Technical Information: TI-20231228

Subject: EH32 (MG4) – Subframe lower guard to battery gap - CEE

EH32 (MG4) – Subframe lower guard to battery gap

Version: V 1.0

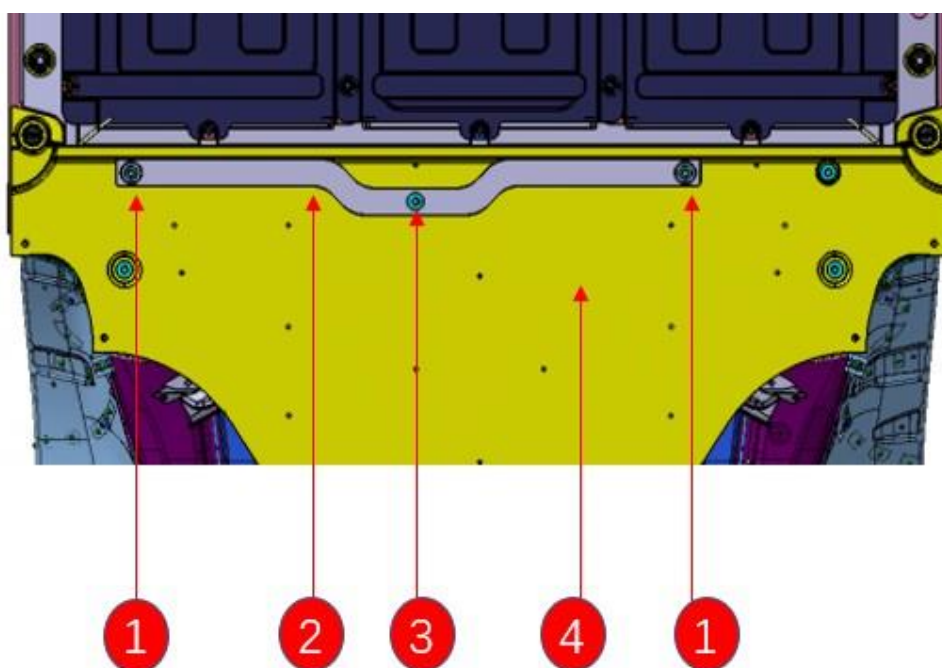
This Technical Information is about a recent product enhancement. After long time driving, the gap between the rear subframe lower guard to the HV battery may be larger (please see a typical example below).

In order to solve the issue of EH32 rear subframe lower guard and battery gap, the following aftersales aluminium alloy bracket (P/N. 11769392) is added, which is externally mounted on the rear subframe lower guard to control the gap. Meanwhile, 2 new long fastening bolts (P/N.90006778) are added to replace the original bolts.

1. Remove the 3 bolts (1 & 3 in illustration) that secure the rear subframe lower guard (item 4).
2. Install the aftersales aluminium alloy bracket (item 2, grey) with the 2 long fastening bolts to the position shown in illustration (item 1) and tighten to 4-6 Nm. The middle mounting point (item 3) is still secured with the original bolts and tightened to 4-6 Nm.
3. Visually check the gap between the rear subframe lower guard and the battery to complete the installation.
